**BEFORE THE BOARD OF PATENT APPEALS
AND INTERFERENCES**

Application Number: 10/706,320
Filing Date: November 12, 2003
Appellant(s): GITTLEMAN ET AL.

EXAMINER'S ANSWER

FIG. 5

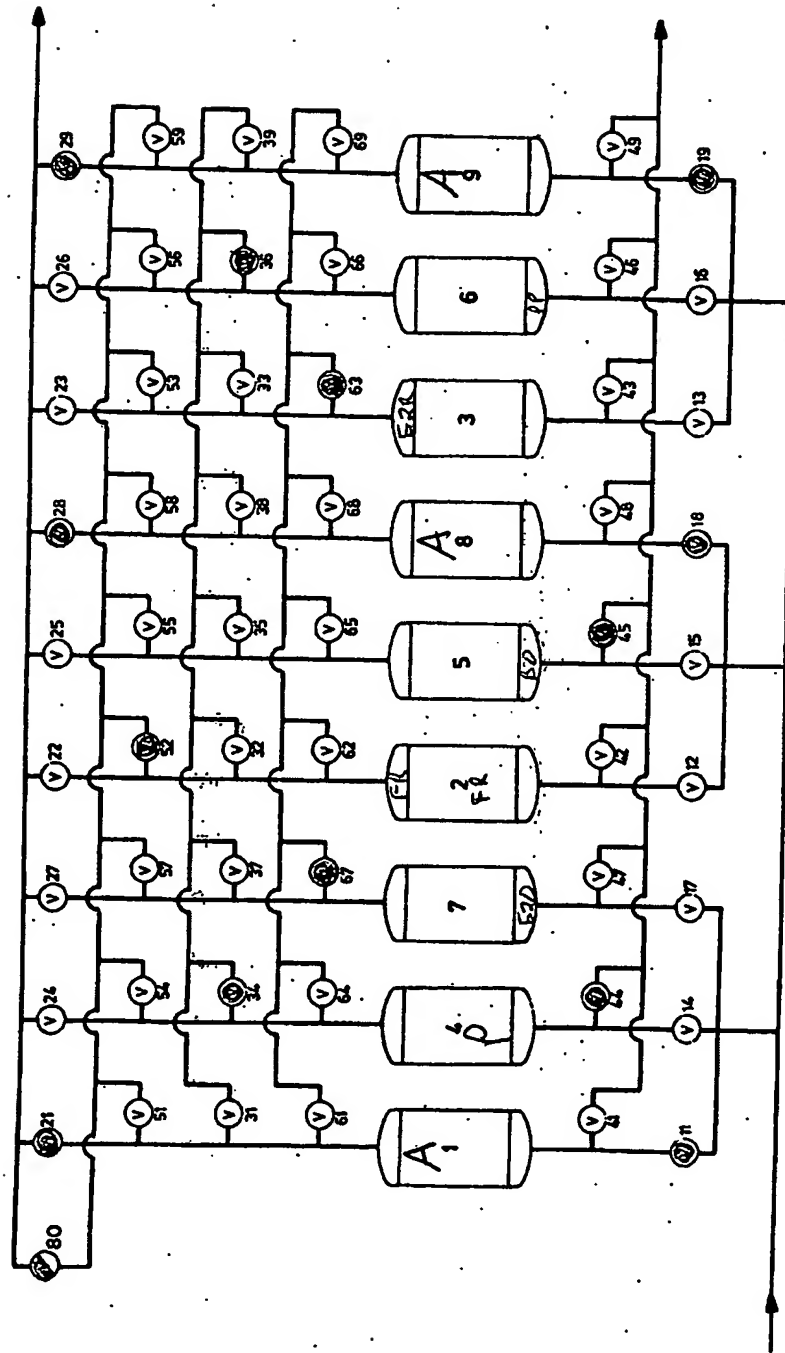
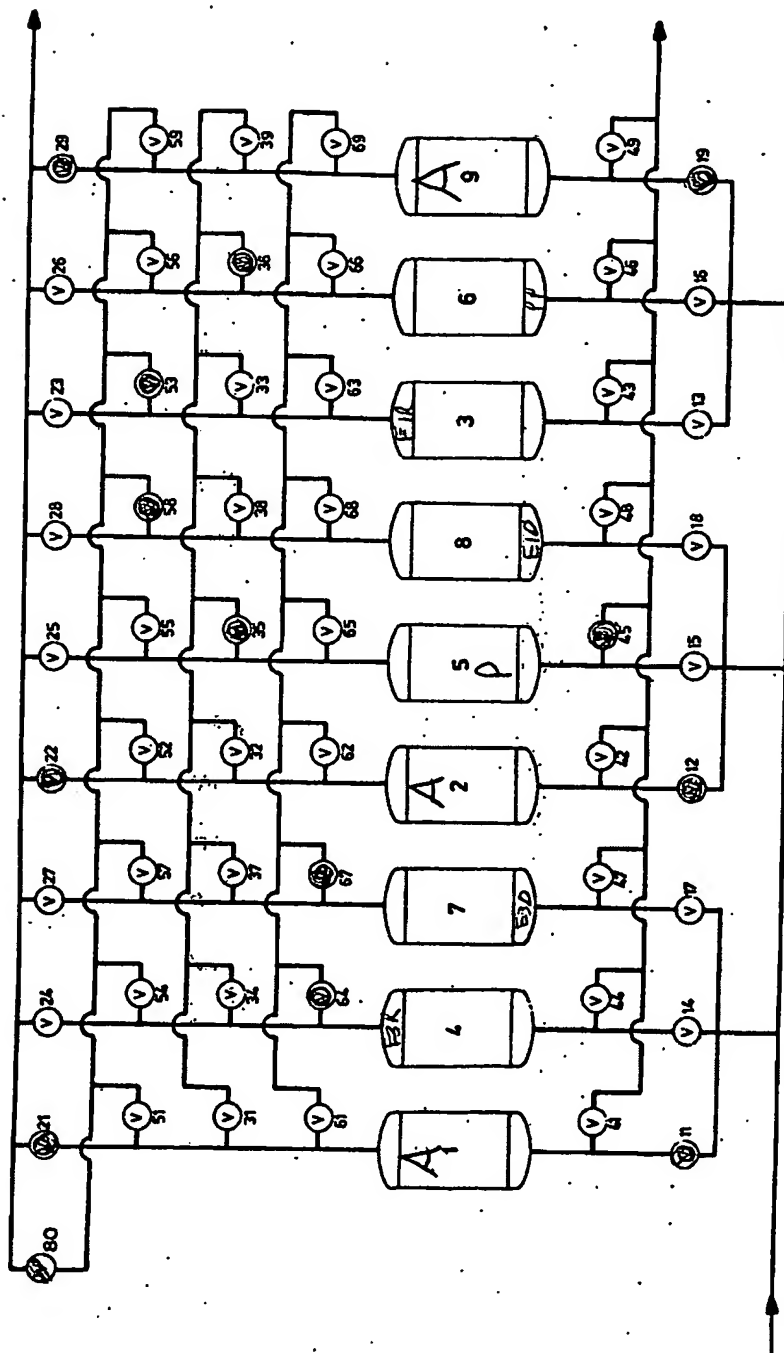
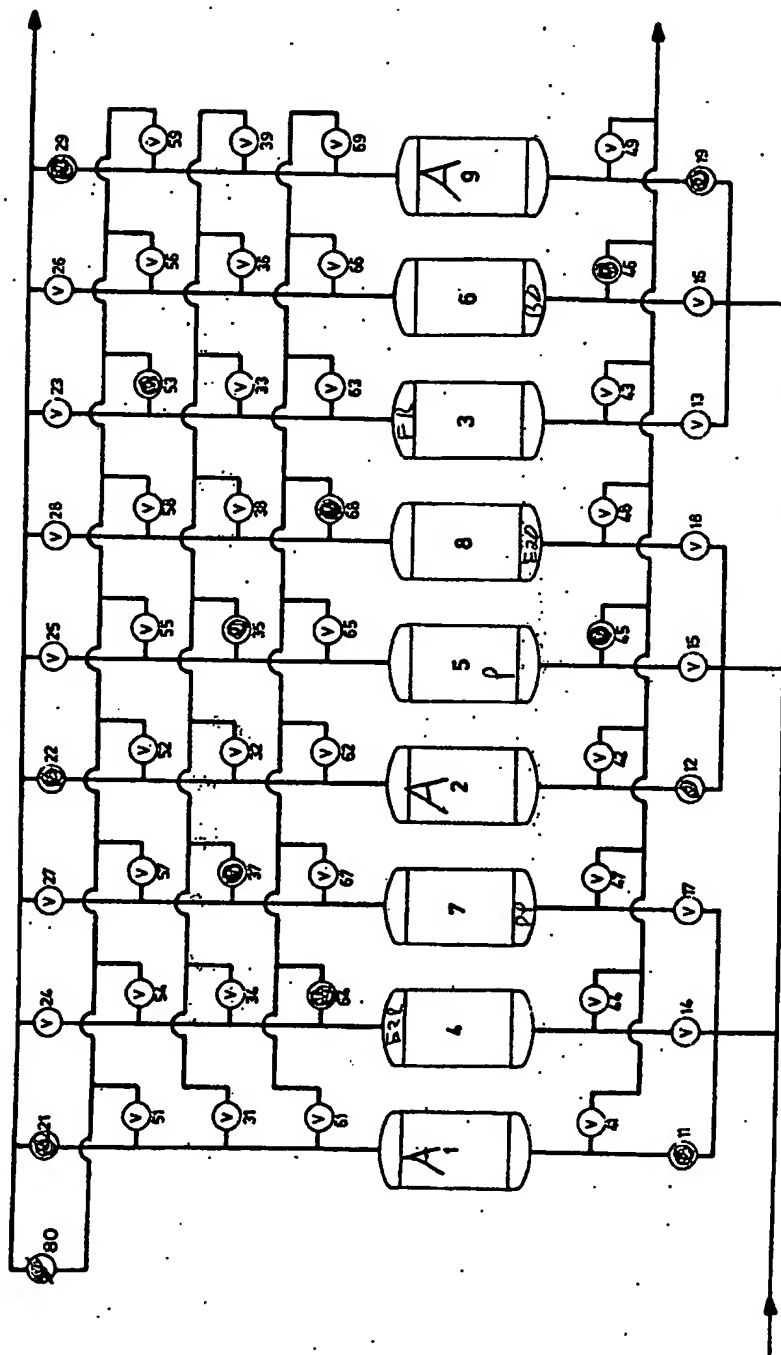
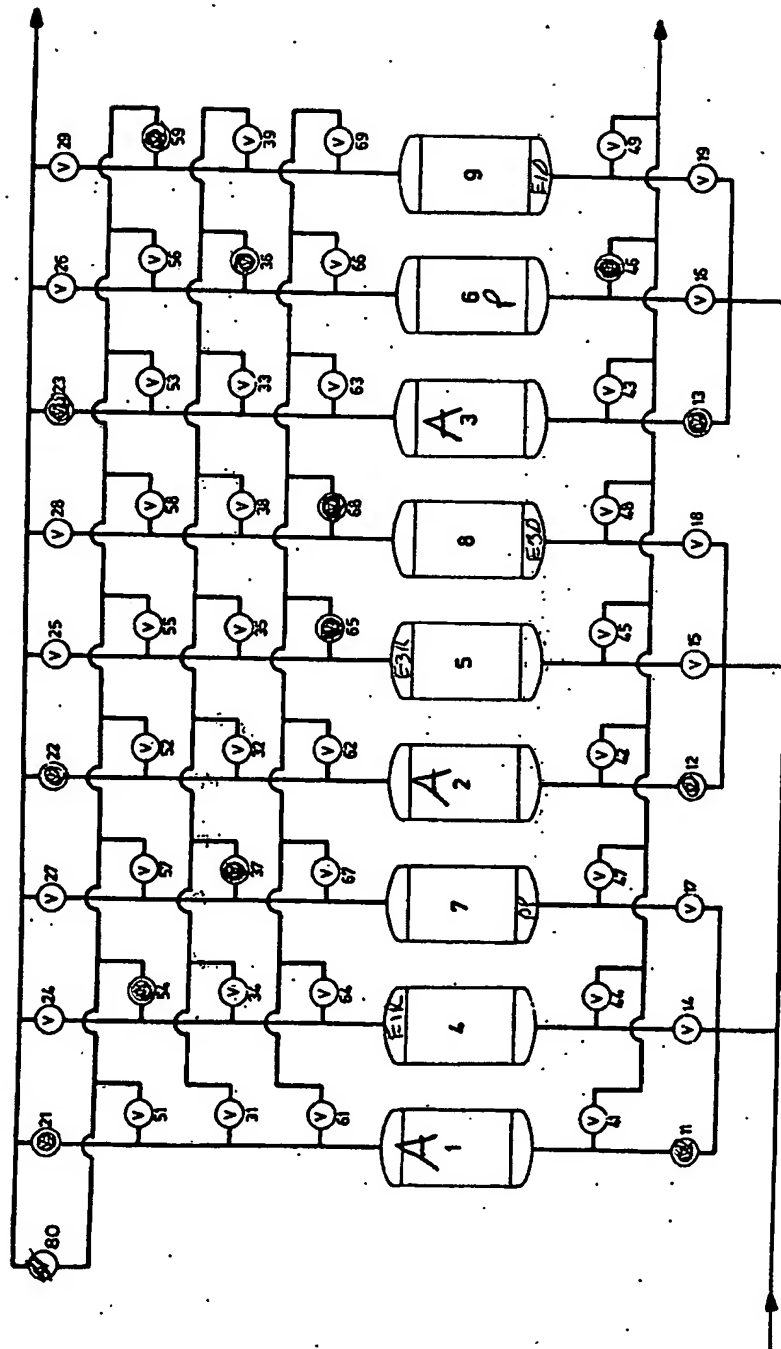
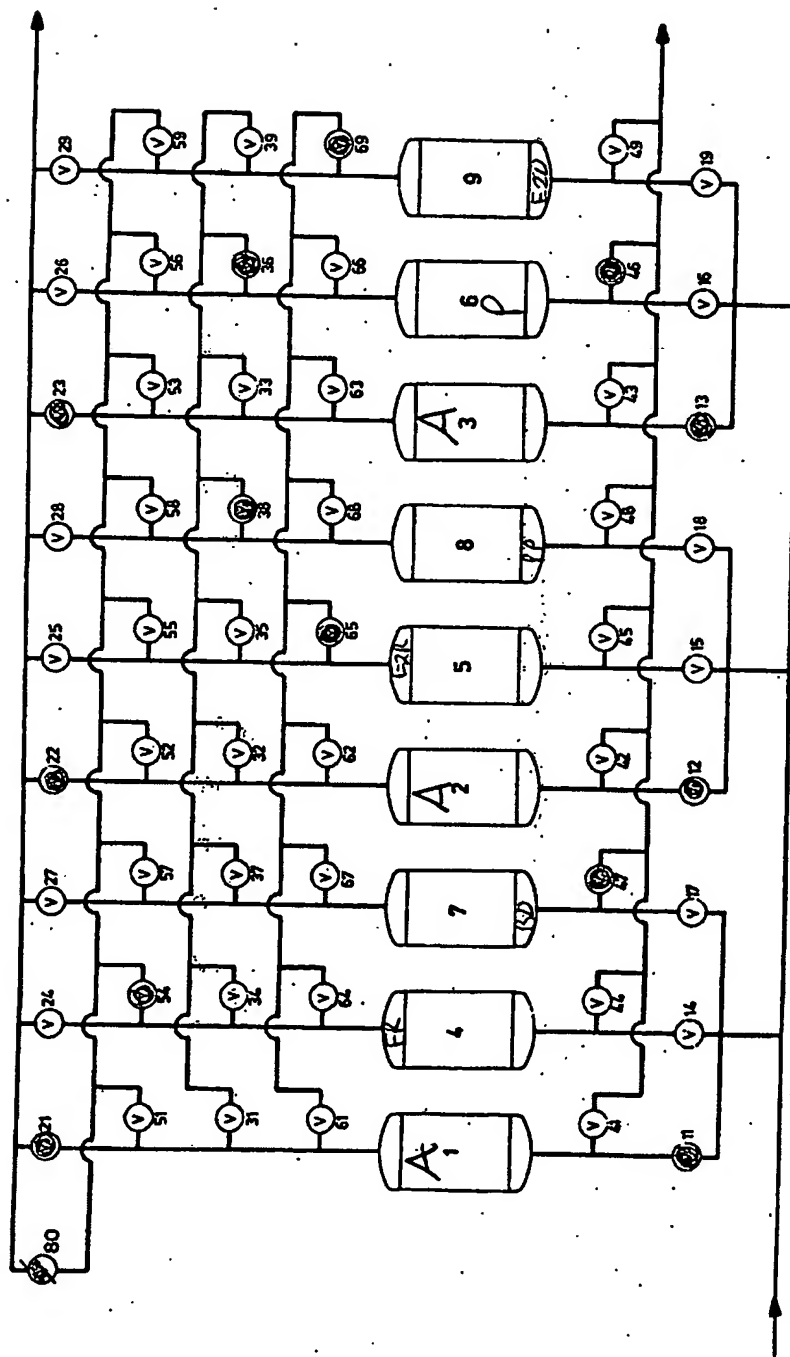
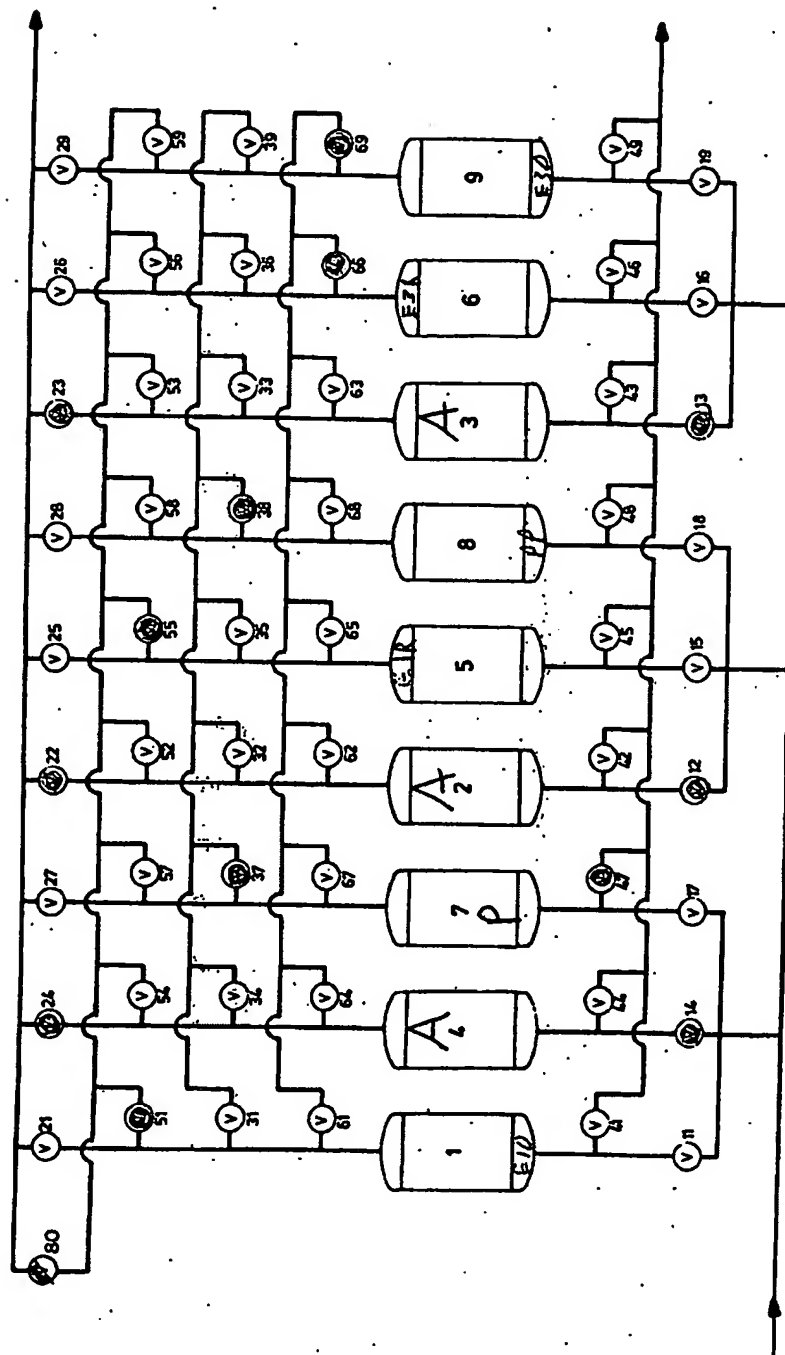
Applicant argues that the blow down step in Fuderer does not take place directly following the equalization down stage, however in the embodiment of figures 5-7 for example, the Fuderer PP stage anticipates the second equalization down stage as claimed because the vessel product end is coupled to the product end of an adjacent vessel at a purge pressure to lower the pressure. For the purposes of anticipation, the PP state of Fuderer is taken to be

Applicant also argues that Fuderer specification does not appear to indicate how the vessels are interconnected during the down stages and PP stage, however the process flow diagram, time diagram, and valve operation chart of figures 5-7, for example, show that the product ends are coupled. To illustrate the process conduit couplings during the system operation, the examiner has attached copies of figure 5 annotated for the first eight time cycles, showing open valves and vessel conditions. Applicant further argues the Fuderer fails to disclose vessel coupling in the PP stage, however note in the first time cycle for figure 5, for example, where vessel 5 in the PP stage is coupled to the product end of vessel 4 which is in a purge stage, via valves 34 and 35. With respect to claim 52, the system is additionally inherently capable of performing all of the steps regardless of the disclosed operation because it contains all of the structural components needed to do so.

Applicant also argues that the Fuderer system does not operate at pressures less than 7 atm, however it is submitted that the prior system operates in a broad range of pressures over its time cycle, including pressures at and between 41-83 psi (about 3-6 atm) during depressurization and blow-down stages (see figures 4a, 4b, col. 9, lines 35-50). With respect to claims 19, 44 and 64, the examiner agrees that Fuderer *alone* does not specifically disclose using a zeolite 5A adsorbent, but does disclose using a calcium zeolite A in an example. It is the examiner's contention that one having ordinary skill in the art would have known to select a type of zeolite that is most effective for adsorbing target contaminants based on cost, availability, the level of contamination, and the desired purity level of the product gas.
